World Forum for Harmonization of Vehicle Regulations**Working Party on Lighting and Light-Signalling****Eighty-ninth session**

UN Regulation No. 10 (Electromagnetic Compatibility)**Proposal for a corrigendum to 06 series of amendments to UN Regulation No. 10 (Electromagnetic compatibility)****Submitted by the experts from by the Informal Working Group on Electromagnetic Compatibility***

Model A

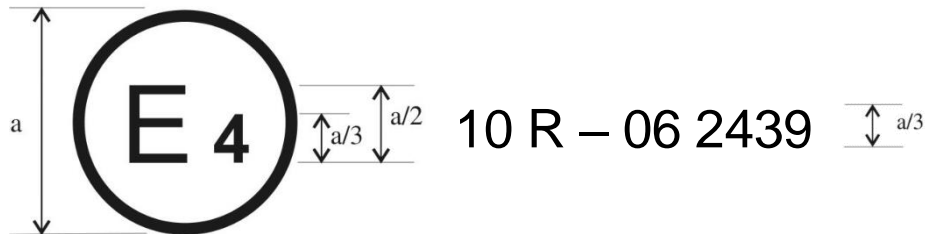
$a = 6 \text{ mm min}$

The above approval mark affixed to a vehicle or ESA shows that the vehicle type concerned has, with regard to electromagnetic compatibility, been approved in the Netherlands (E 4) pursuant to Regulation No. 10 under approval No. 065 2439. The approval number indicates that the approval was granted according to the requirements of Regulation No. 10 as amended by the 06 series of amendments."

1. In Annex 1, for the first example of markings, a 'min' is missing after 'a = 6 mm' as in Model B. The approval number is also corrected in the text.
2. In Annexes 4 and 6, paragraphs 2.3.3. and 2.4.4., references to figures are incorrect and need to be modified. The missing text at the end of the second indent in paragraph 2.4.4. should be reintroduced as well.
